THE HIGHWAY TRAFFIC ACT (C.C.S.M. c. H60)

Traffic Control Devices Order, amendment

Regulation 152/2001 Registered October 3, 2001

Manitoba Regulation 264/88 amended

MR-123

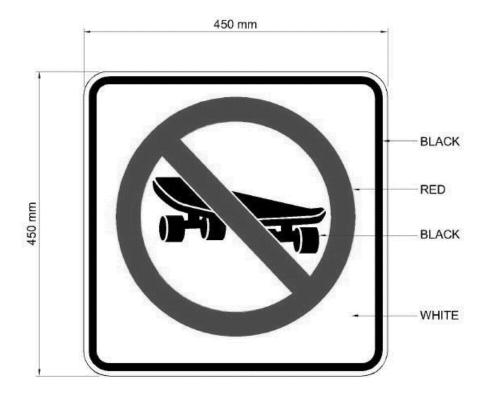
Skateboarding Prohibited sign (MR-123)

65.12(1) A "Skateboarding Prohibited" sign shall be used to make known that skateboarding is prohibited on the sidewalk.

- 65.12(2) A "Skateboarding Prohibited" sign shall
 - (a) be square in shape;
 - (b) be not less than 450 mm along each side;
 - (c) be white in colour and display in black a design consisting of a skateboard within an annular red ring not less than 300 mm in diameter and with a diagonal red bar across it;
 - (d) be reflectorized to show the same colour and shape by night as by day;
 - (e) bear the markings and have the dimensions illustrated in the following figure;
 - (f) the traffic authority must reference the supporting by-law (by name or number) displayed in black letters not less than (10 mm) in height in the lower right hand corner of the sign.
